[Docket No. 2002–NM–128–AD; Amendment 39–13269; AD 2003–16–16]

**Airworthiness Directives; Boeing Model 747–400 Series Airplanes Equipped With General Electric Model CF6–80C2 Series Engines**

ACTION: Final rule.

Electro-Mechanical Brake and CDU Cone Brake Torque Check  
Figure 1

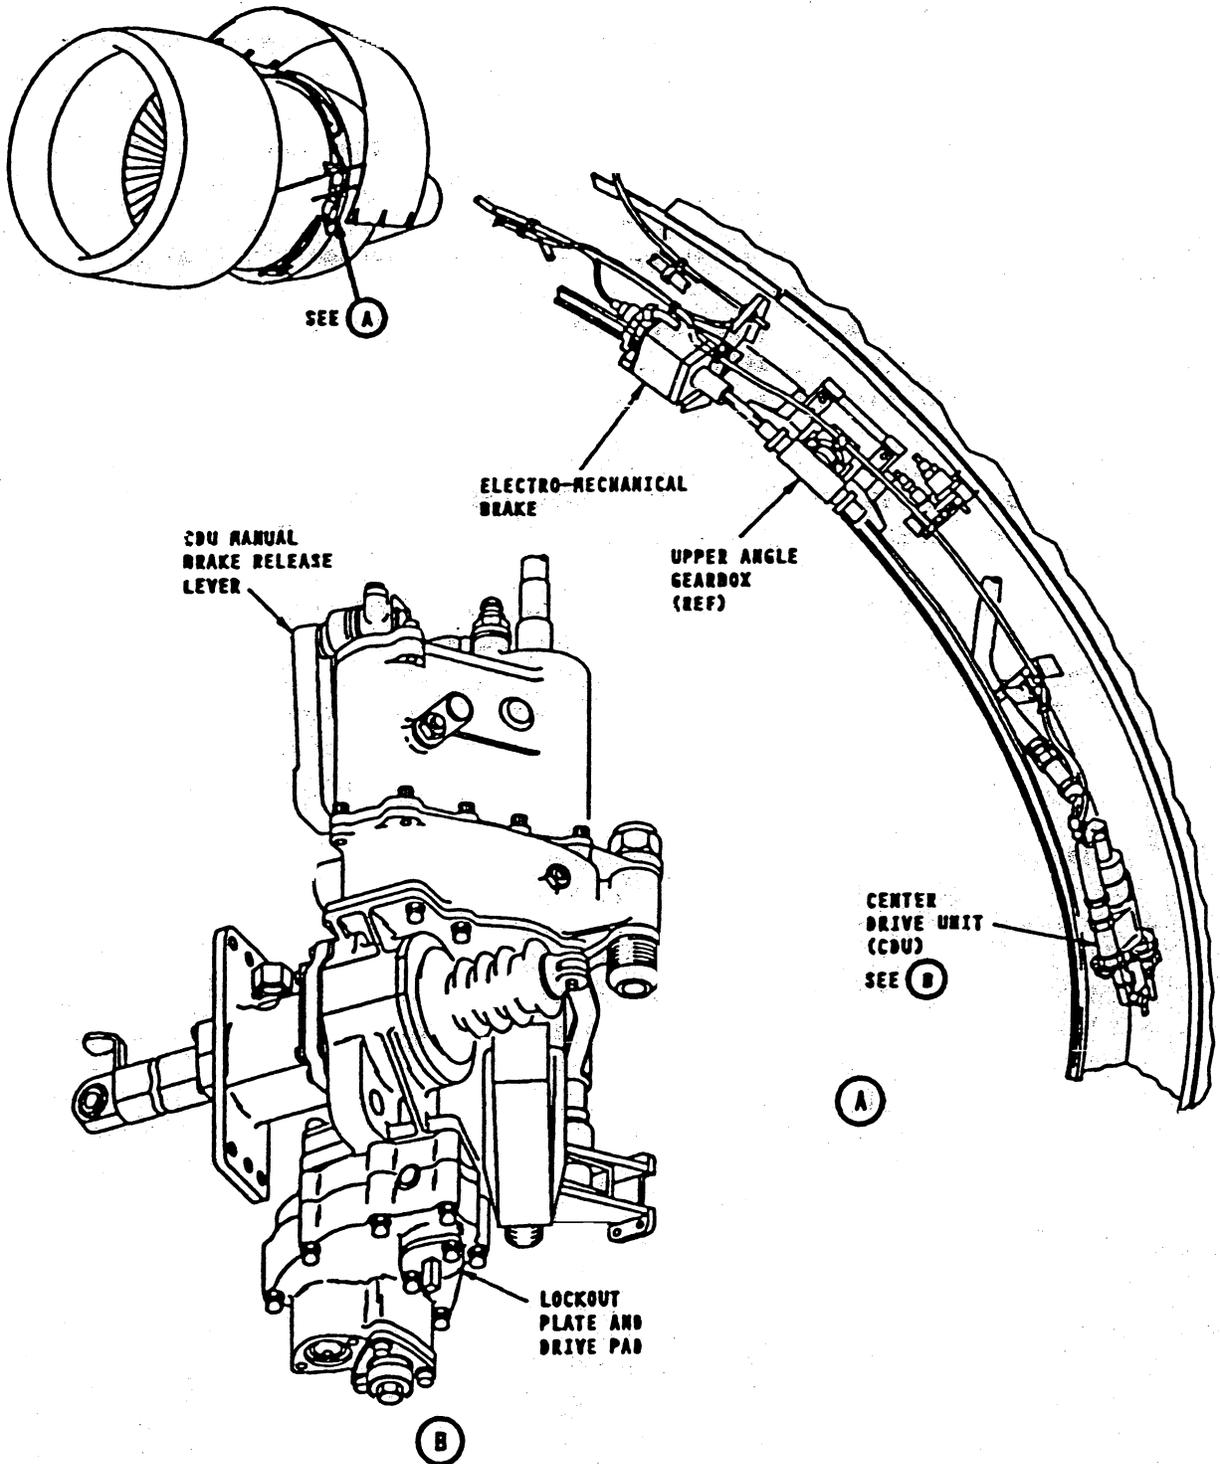
2. CDU cone brake check (Figure 1):

(6) Install a 1/4-inch drive and a dial-type torque wrench into the CDU drive pad.

**Caution:** Do not use more than 100 pound-inches of torque when you do this check. Excessive torque will damage the CDU.

(7) Turn the torque wrench to try to manually extend the translating cowl until you get at least 15 pound-inches.

**Note:** The cone brake prevents movement in the extend direction only. If you try to measure the holding torque in the retract direction, you will get a false reading.

(8) If the torque is less than 15 pound-inches, you must replace the CDU.
